## City of Lewisville, TX Agenda

### Joint Meeting of the Planning and Zoning Commission and Transportation Board

**Tuesday August 4, 2020**

**SUBJECT: Development Plan/Preliminary Plat of Lewisville Corporate Center Addition, Lot 2, Block A; on 6.641 Acres out of the Steven Riggs Survey, Abstract Number 1088; Zoned Planned Development – Mixed Use (PD-MU) District; Located on the West Side of State Highway 35 East (I-35E), Approximately 850 Feet South of Justin Road (F.M. 407), Being a Replat of Lot 2, Block A, Lewisville Corporate Center Addition.**

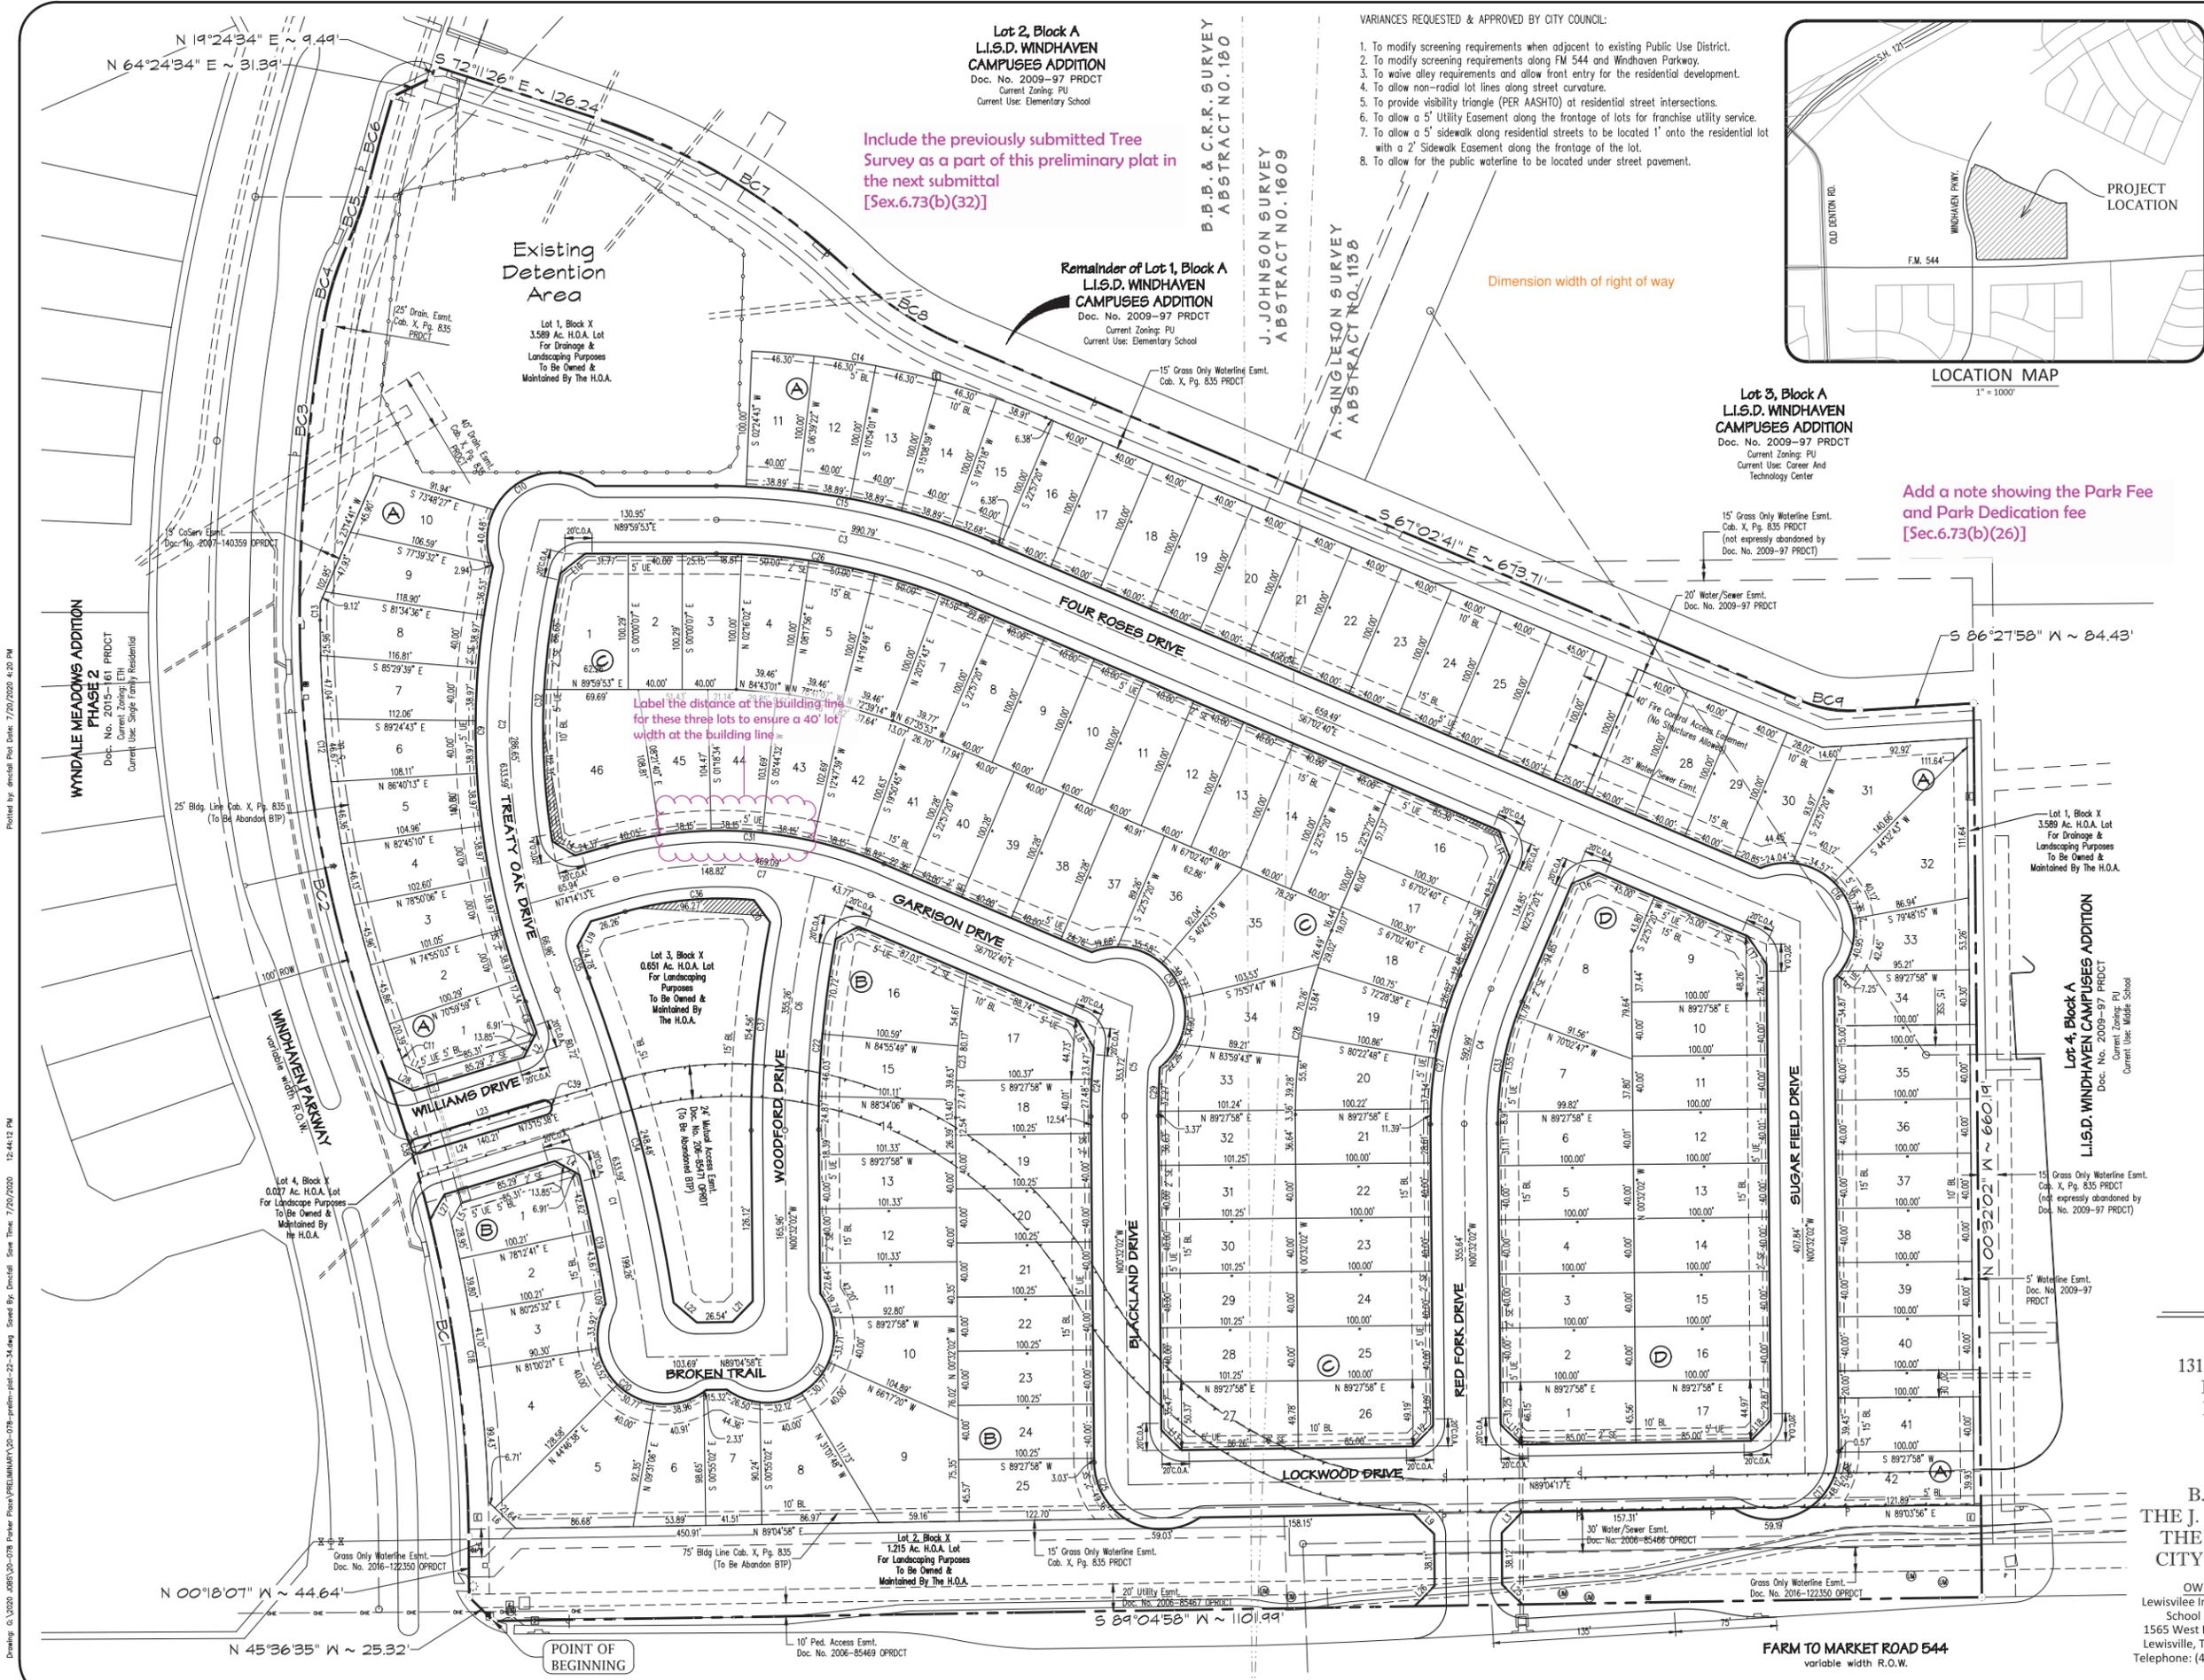
- Control of access must be shown on corner clips

- Easements must meet City specification
- Screening walls are not allowed on water or sewer easements

- Sewer line must be located within easement.

Add a note showing the Park Fee and Park Dedication fee [Sec.6.73(b)(26)]
